Memorandum

From: Ryan McEvoy, PE – SLR International Corporation

Subject: Stormwater Management Basin –Lanzieri Court
Derby, Connecticut

Date: November 15, 2021

Photo No. 6	Direction Photo Taken: East	Visit: October 6, 2021	Issued: November 15, 2021
--------------------	------------------------------------	-------------------------------	----------------------------------

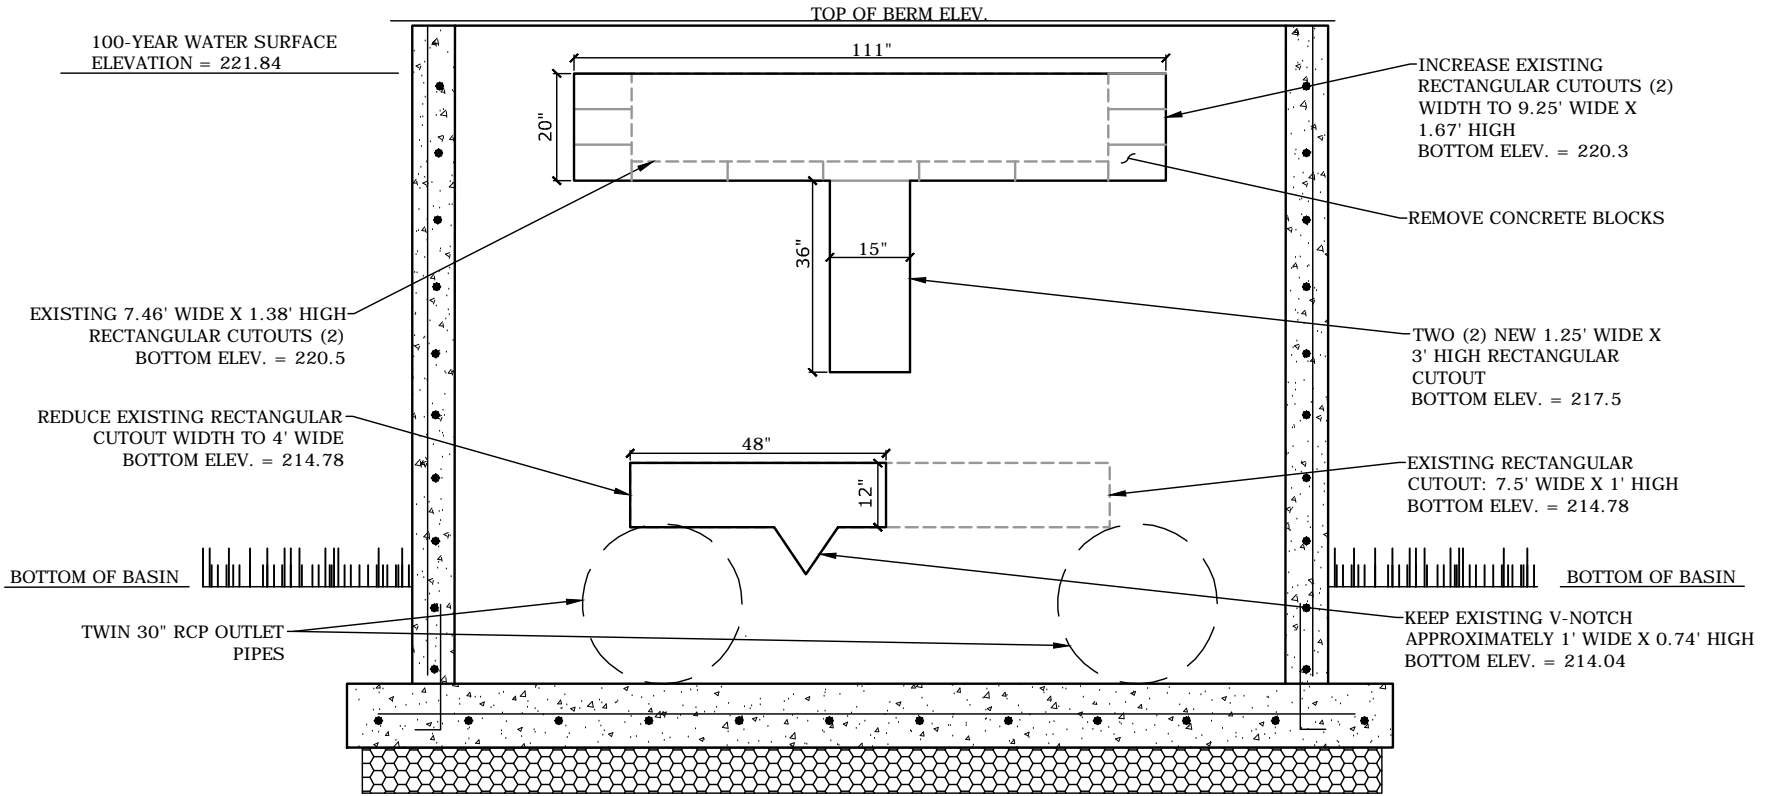
'V' shaped cut-out in the front of the OCS at the lower opening
